# **Determination 2019/062**

# Regarding the means of escape from fire from a new dwelling located behind an existing dwelling at 220 Clyde St, Wellington

This determination concerns a new dwelling constructed at the rear of a site with an existing dwelling, and compliance of the new dwelling in relation to movement to a place of safety in the event of a fire. The matter at issue is whether the escape route to a safe place for the occupants of the rear dwelling required a protected path past the existing dwelling.

Figure 2: Site plan showing approximate locations of the dwellings and the pathways (based on the consented plans)

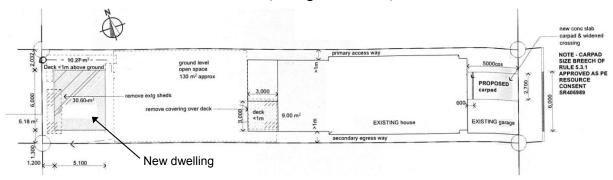
- 2.7 On the southern side, the consented plans show a gap between the garage and the boundary, with access to the footpath continuing in a straight line past the garage's southern wall to the street front (see figure 2 below).

2.8 However, after receiving the application for determination and viewing images of the property online it was apparent to me that the garage wall is against the boundary fence. In response to a request to clarify the location of the garage and the proposed means of egress and proposed fire-rating, the agent provided an updated site plan. See Figure 3 below. It is clear from this that the southern pathway is not able to be used for access to/from the new dwelling.
